### **GJETO'S SALON AND SPA, SITE PLAN NUMBER 07-48**

Consideration of the request of Gjeto's Salon and Spa for a Section 9 Façade Waiver. The subject property is located in Section 15, south of Twelve Mile Road, west of Novi Road, in the Twelve Mile Crossing at Fountain Walk shopping center.

## PLAN REVIEW CENTER REPORT

Re: **FACADE ORDINANCE – Final Site Plan Review**  
**Gjeto's Salon Spa, Twelve Mile crossing**  
**SP-07-48, Façade Region 1, Zoning District RC, Build-out size: 2,832 sq.ft.**

WEST ELEVATION  
 SCALE: 1/8" = 1'-0"

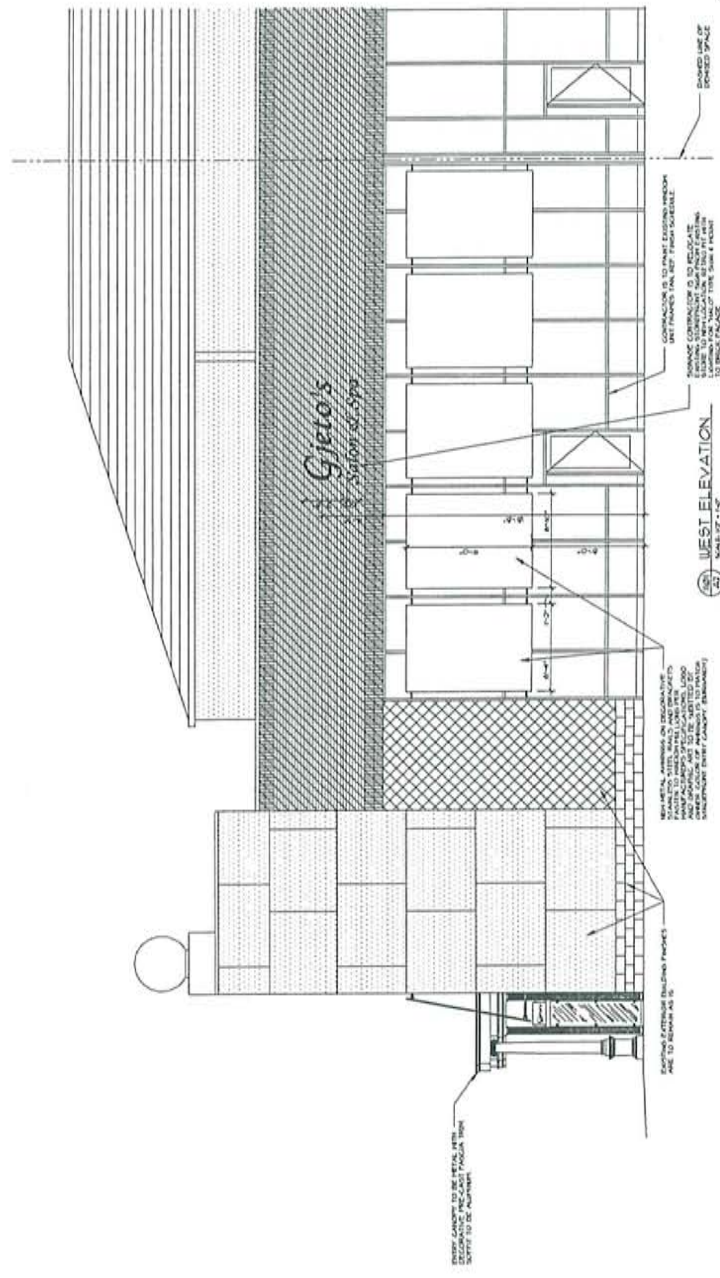
Drawings Dated 04-26-07	NORTH FACADE	SOUTH FACADE	EAST FACADE	WEST FACADE	ORDINANCE MAXIMUM
NATURAL CLAY BRICK	15.9% X			31.6% ✓	100% (30% Min.)
SPLIT-FACED CMU	2.6% X			2.6% X	0%
FLAT METAL PANEL	6.2% ✓			18.6% ✓	50%
COLUMNS (MOLDED TRIM)	3.0% ✓			1.9% ✓	15%
E.I.F.S.	72.3% X			45.3% X	25%

1. The applicant will be required to obtain a Section 9 waiver for three existing materials – The use of existing split faced C.M.U., percentage overage for existing E.I.F.S. system and underage of brick material.

The use of existing Split-Faced Concrete Masonry Units is not allowed in Region 1 but is used in a way that simulates a stone base. The proposed design does not incorporate any change to the existing brick or E.I.F.S. systems. Taking in account only the actual limits of the build-out in the overall façade, the amount of brick is less than the required 30% minimum for Region 1 on the North façade, and both the North and West façades exceed the allowable percentages for the E.I.F.S. material. All of these infractions are currently within an existing theme and all proposed new materials fall within the guidelines of the ordinance.

*a.) We have acknowledged the review by Metco Services. As stipulated we are not changing any of the existing building finishes. It is also understood that all these issues fall within the guidelines of the Ordinance, and a Section 9 Waiver is to be obtained.*
